# Goathill North Final Mitigation Design Report - Part 1

## **GOATHILL NORTH FINAL MITIGATION DESIGN REPORT**

Submitted to: Molycorp, Inc.

**RE: Goathill North Final Mitigation Design Report – Part 1**

FIGURE 2  
QUESTA MINE  
GOATHILL NORTH  
SECTION E-E'  
WITH TOE BERM OPTIONS

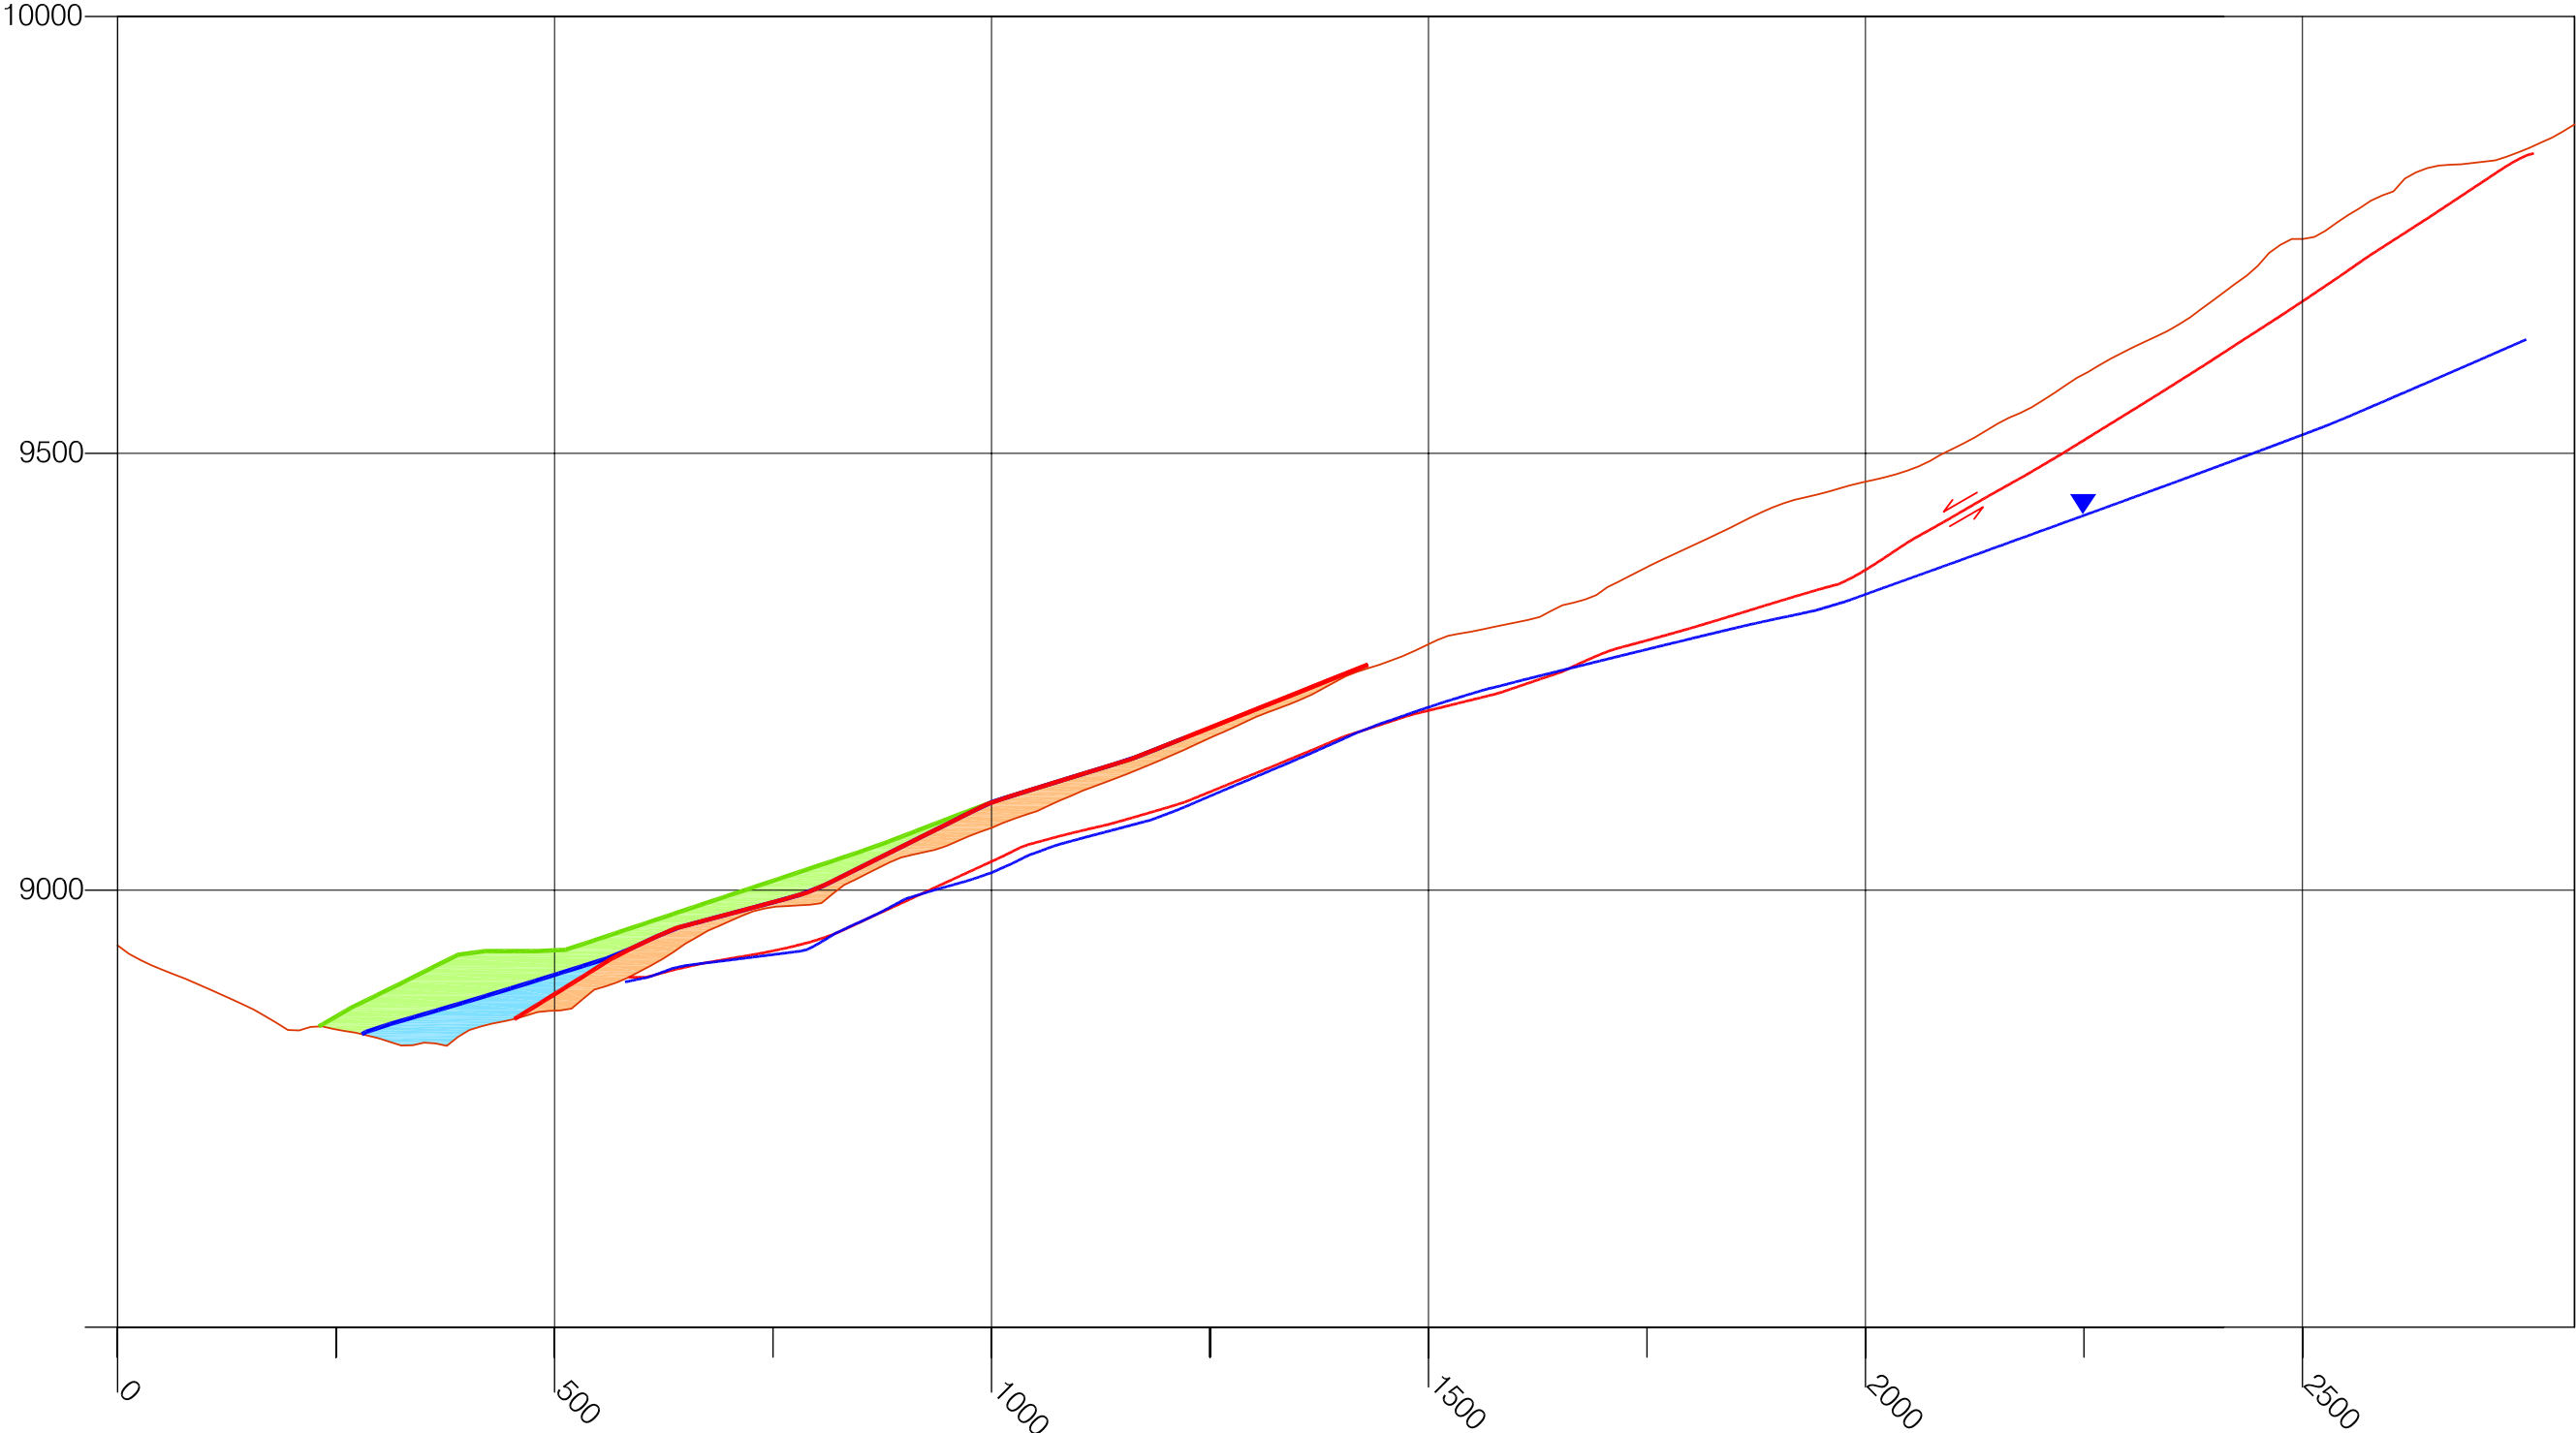
Although the slide is not currently moving entirely in a down valley direction, the mitigation needs to ensure that the whole mass is not directed down valley as a result of the fill placement and mass re-distribution. This is an important issue which has been raised by the Stability Review Board during review of the draft report and it is the primary purpose for the discussion of 2D and 3D down valley stability presented here.

- ❖ There is a difference between the mitigated 2D versus 3D factors of safety in the range of 18-19%. This reflects the additional lateral shearing resistance that is provided by the buttress fill. A comparison of Figure 5.11 and Figure 6.12 in the feasibility report shows that there is a significant increase in the surface area of the shear surface after the fill is placed. It is difficult to account for this shearing resistance using 2D analysis because of the complex geometry.

Table 2 shows average safety factors from 10 cross sections constructed parallel to Section E at 50ft spacing. Drawing 2 shows the locations of these sections across the 40,000yds<sup>3</sup> fill option area and the detailed results are compiled in a table attached to this letter, along with all of the stability cross sections. Because of the lateral changes in geometry at the toe of the slide, the average safety factor for the 10 sections is slightly higher (by 3%) than the safety factor on section E by itself. Most importantly, the averaged value of 1.15 for the 10 sections is the same (when rounded to 3 significant figures) for the proposed design and with the additional 40,000yds<sup>3</sup>. The 40,000yds<sup>3</sup> fill increment is too small a mass relative to the whole slide to significantly increase the safety factor in the down valley direction.
